Technical Bulletin

Category: Technical TSB No. TS 00 06290

SUBJECT: SAFETY RECALL CAMPAIGN: SG, COUNTERMEASURE OF

MODEL(S): KIZASHI (A6B424)

Part Number	Description	Qty.	Notes
73890-57L01-RX0	Box, I/P Ctr Lower	1	Pictured below without counter lock

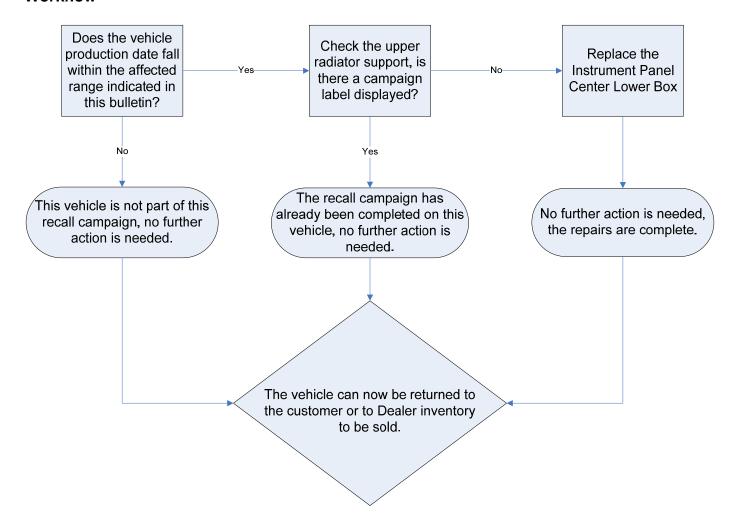
CONDITION: The hinged door on the instrument panel center lower box may not remain

CAUSE: Improper design of the latch mechanism.

CORRECTION: Please replace the instrument panel center lower box with a new replacement
